YONGE STREET LINEAR PARKS IMPROVEMENTS

WHAT WE HEARD REPORT PHASE 2: PREFERRED DESIGN CONCEPTS

January to March, 2021

Prepared by Dept of Words and Deeds and PMA Landscape Architects
for The City of Toronto

Figure 11. The plan above shows the preferred design concept for: George Hislop Park.
 Please note: North direction is to the left.
 For more information, see [the presentation from the Virtual Public Meeting #2](#)

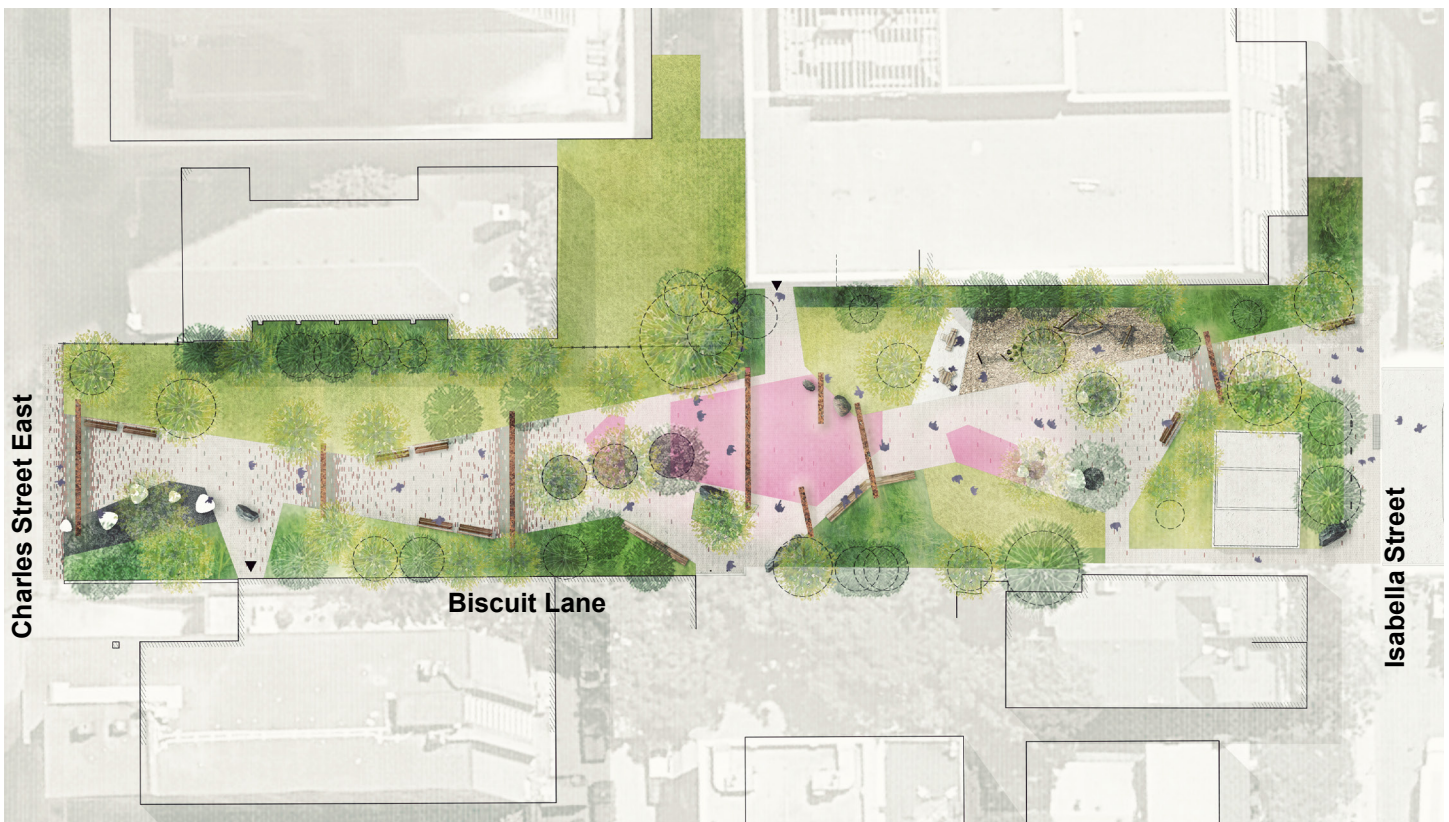
5. A flexible, open plaza design that can accommodate events in George Hislop Park is preferred.
6. Some existing gate access points from the private property on the east side of Norman Jewison Park do not lead to pathways and should be closed or removed.

8. The integration of the laneways in George Hislop Park and Alexander Street Parkette are a high priority.
9. A re-interpretation of the commemorative water fountain/pet drinking fountain is a welcome addition to Norman Jewison Park, but the proposed design and location should be refined to address tripping hazards and other issues.

- 86% of participants feel that the proposal has a good variety of types of seating and places to sit both alone and in small groups.
- 84% of participants feel that the proposal's design of walkways and additional access points from the laneways, seating locations and types, clear sightlines, and lighting helps the park feel welcoming and safe for all users.

- 78% of participants feel that the size and layout of the paved paths enhance the park experience by providing both direct routes and multiple ways to move fluidly through the park.

- 79% of participants feel that the park proposal, including the Central Plaza, is flexible enough to accommodate small organized events but is also functional and designed appropriately for daily use.

- 81% of participants feel that they are satisfied with the location and size of the proposed playground area.
- 72% of participants feel that they are satisfied with the proportion of lawn areas vs. planting beds.

- 67% of participants feel that they are satisfied with the amount of paving and green space in George Hislop Park.

The LGBTQ2S+ piece is too industrial.
The LGBTQ2S+ piece looks great!
The LGBTQ2S+ piece looks fun and vibrant.
Would love to see more colourful flowers.
That's such a good idea.
The arches look apocalyptic.
Please do not use Corten for the beams.
The LGBTQ2S+ piece draws you in.
The LGBTQ2S+ piece is too built-up.
I really like the colour in the Dance.

Figure 13. The plan above show the preferred design concept for: 1- Alexander Street Parkette.

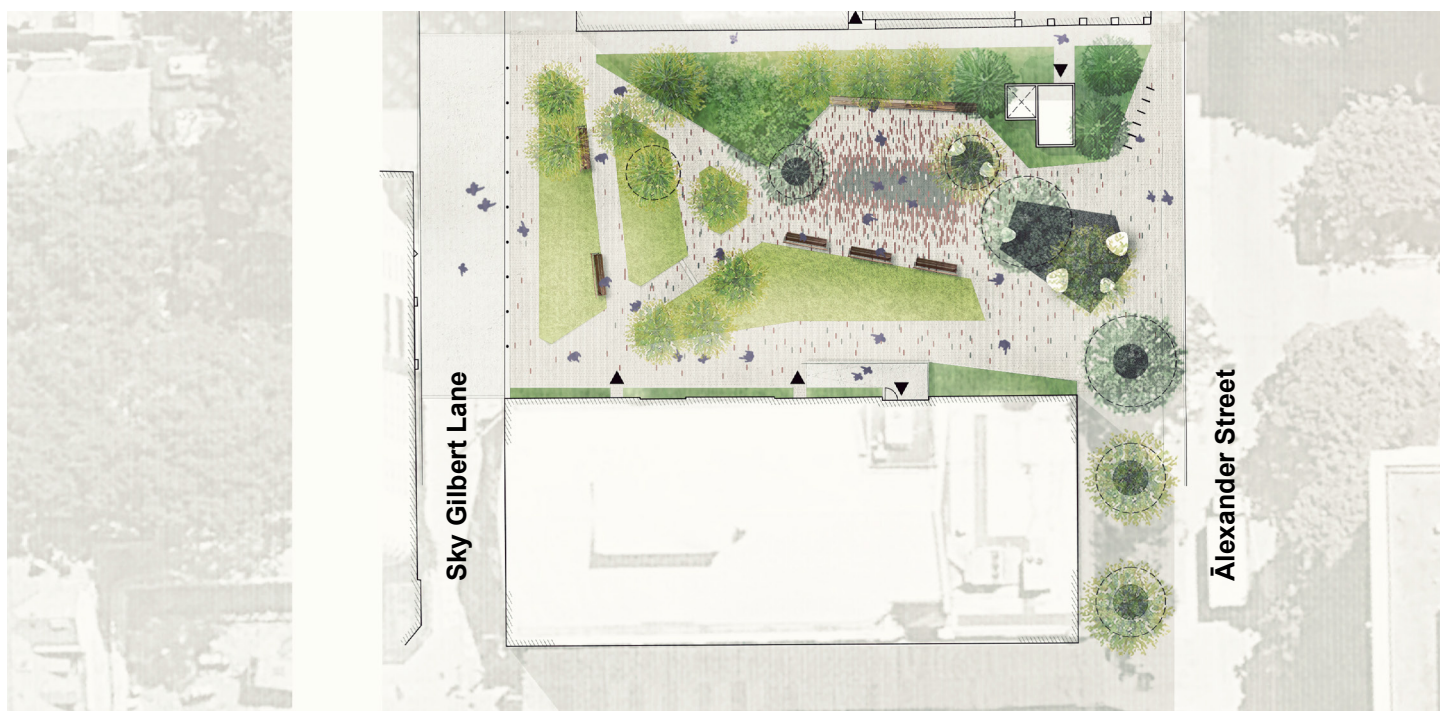
- 79% of participants feel that the central plaza feels like a welcoming space for day-to-day activities or for community events.
- 79% of participants feel that the design of the park (including walk ways, and seating, and sightlines to laneways) help the park to feel welcoming and safe for all users.
- 77% of participants feel that the size and layout of the paved paths enhance the park experience by providing both fluid circulation and direct routes through the park.
- 75% of participants feel that the proposal has a good variety of seating types and places to sit both alone and in groups.
- 72% of participants feel that the proposal has a good proportion of lawn areas vs. planting beds.
- 65% of participants feel that the proposal achieves the right balance between paving and green space.

Alexander street parkette could allow for a 'speaker's corner' podium, like that which stood outside City Hall.

Another resident of the apartment buildings nearby wrote to say he does not use the Alexander St Parkette because it is 'too small, messy, smells and has too many dogs'. He also thought that adding brighter lights at night would make it feel safer.
